Reply to Reviewers

Manuscript ID WES-2026-116

Title: Effects of atmospheric thermal stratification on wake aerodynamics
of a regenerative wind farm unit

Fig. S1: Same as Fig. 15 but plotted with $\Xi_{\pm 0.5D}(x)$. That is, confining the lateral extent from $-2.5D \leq y \leq 2.5D$ to $-0.5D \leq y \leq 0.5D$. This figure is now included in the manuscript as Fig. F1.

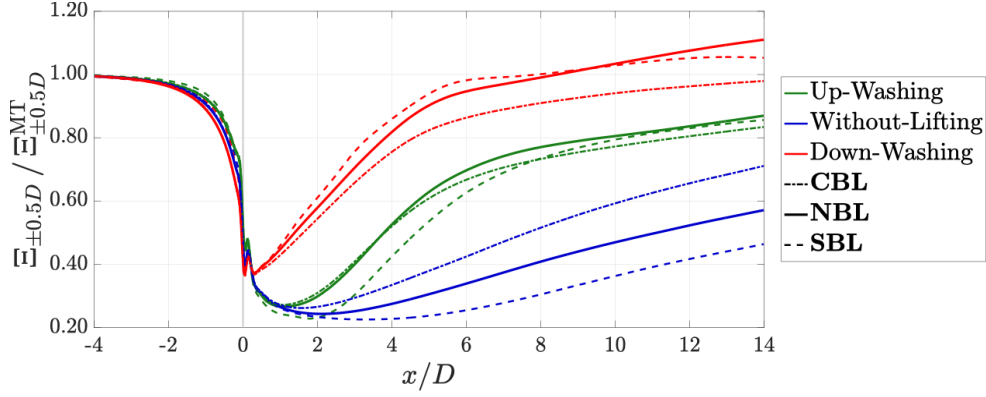
Looking at Fig. 6, especially for the stable case, there appears to be a significant negative deficit, i.e., an acceleration of the flow, which reaches the lower part of the "rotor" starting at 6D in the DW case. This is quite interesting because it would imply a hidden benefit for downstream devices with down washing. However, when I looked at Fig. 15, somehow this advantage is not there or is washed out with the variable ξ . I think that the reason might be the limits of the y-integration in Eq. 12. Extending the calculation to 5D laterally is excessive because the available power that truly matters is just that going through the rotor. The reasoning that "wind direction changes continuously in a wind farm" is not really applicable in this case because the wind direction did not change at all in these simulations. Plus, again, even if the wind direction changes, the MRS� would always face the wind, thus only the lateral extent of $\pm 0.5D$ matters. I kindly request that you re-evaluate Eq. 12 and Fig. 15 using a more realistic range of $\pm 0.5D$ for the the y-integration. I suspect that the DW case will appear more appealing this way. This modification will affect Table 2 also.

Nevertheless, we fully agree that evaluating the available power over $-0.5D \leq y \leq 0.5D$ is also physically meaningful, since this range corresponds directly to the lateral extent of a single MRSL, acting as a characteristic scale. In response to the reviewer’s suggestion, we have therefore repeated the analysis presented in Section 6.6 using this narrower integration range. Following the structure of Eq. (12), we define the corresponding quantity as

and the resulting values are shown below in Fig. S1, a revised version of Fig. 15.

As anticipated by the reviewer, when the lateral extent is restricted to $-0.5D \leq y \leq 0.5D$, the DW configuration becomes the most favorable of the three configurations. This result is consistent with the locally accelerated flow observed in Fig. 6, particularly under the neutral and the stable conditions. However, we note that part of this apparent advantage arises because the DW configuration redistributes the low-momentum wake laterally away from the regions close to $y = 0.0D$. While this is beneficial for a downstream MRSL located directly behind the upstream unit, the laterally displaced low-momentum region may still affect other downstream devices in a wind farm configuration, particularly when successive rows are laterally offset relative to the inflow direction.

For this reason, we consider the wider integration range to be more representative of the overall aerodynamic influence of an MRSL in the wind-farm context considered in this study, whereas the results of $\Xi_{\pm 0.5D}$ provide a complementary, device-centered perspective. To keep the discussion in the manuscript focused, we have therefore retained the wider-range analysis as the main metric. Nevertheless, for completeness, we have added the analysis based on $\Xi_{\pm 0.5D}$ to Appendix F, including the corresponding results and discussion presented in this response.

Fig. S2: Same as Fig. 7 but replaces $|y|^{\text{WC}}$ with y^{WC} and broadens the range for x , making it starting from $x/D = -4.0$.

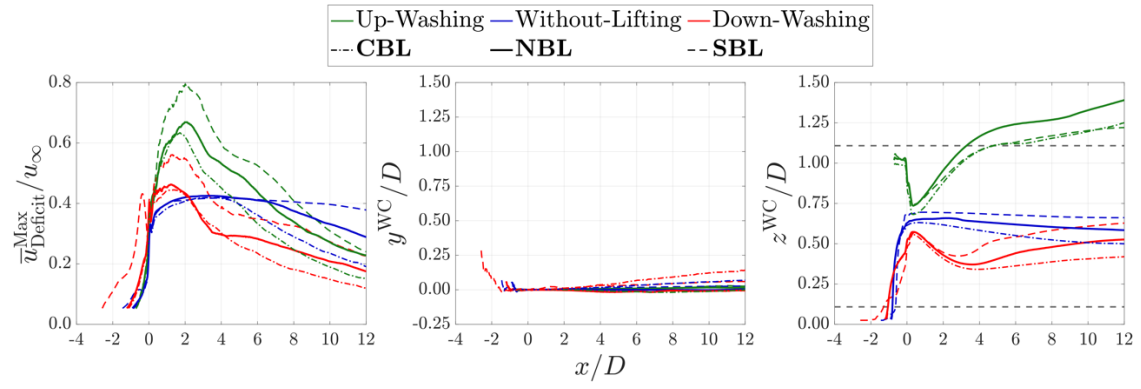
Why are the three cases starting at 0.3 in Fig. 7 (middle)?

Why does the wake center first rise and then drop in the DW case, and vice versa in the UW case, in Fig. 7 (right)?

First, $|y|^{WC}/D$ does not start from zero because Eq. (9) is formulated using the absolute value of the lateral coordinate, $|y|$. Therefore, $|y|^{WC}/D$ represents the deficit-weighted mean absolute lateral distance from the centerline, rather than the signed lateral position of the wake center. Consequently, even for a laterally symmetric wake, $|y|^{WC}/D$ remains non-zero. If $|y|$ in Eq. (9) is instead replaced by the signed coordinate y , i.e., by defining

the resulting signed wake-center position remains close to zero for all cases because of the lateral symmetry of the MRSL and its wake. This behavior can be directly observed in the middle panel of Fig. S2.

To provide a more complete picture, we have extended the wake-center results further upstream, as shown in the right panel of Fig. S2. It can be seen that the vertical wake-center positions already differ considerably among the configurations. However, these values should be interpreted with caution. As shown in the left panel of Fig. S2, the velocity deficit is still relatively small in this region. Consequently, the deficit-weighted wake-center position becomes sensitive to relatively small variations in the velocity field, and its physical interpretation is therefore less robust.

For this reason, we consider the wake-center position to be more physically meaningful after the pressure-recovery process has largely ceased, which approximately corresponds to the streamwise location where the maximum velocity deficit reaches its peak. Beyond this region, the velocity deficit is sufficiently developed for the wake-center metric to provide a more representative indication of the overall wake displacement. This downstream region is also of greater practical relevance when considering interactions with subsequent MRSLs in a wind-farm configuration. We have added this clarification to the second paragraph of Section 6.2, reads as following: “Here, it should be noted that interpretations based on the wake-center positions are most meaningful after the pressure recovery process has ceased, which is typically identified as the streamwise location where $\bar{u}_{\text{Deficit}}^{\text{Max}}$ reaches its peak according to the classical actuator-disk theory (Manwell et al., 2010). Prior to this location, $\bar{u}_{\text{Deficit}}$ remains relatively small as the wake continues to decelerate, making the deficit-weighted wake-center positions less representative of the developed wake.”

Regarding the specific reason why the wake center initially rises and then drops for the DW configuration, while exhibiting the opposite tendency for the UW configuration, we cannot provide a definitive explanation based on the present analysis. We suspect that this behavior may be related to the resulting induced velocity field due to the bound circulation system of the lifting devices. However, further dedicated analysis would be required to confirm this interpretation, and we therefore prefer not to draw a firm conclusion at this stage.
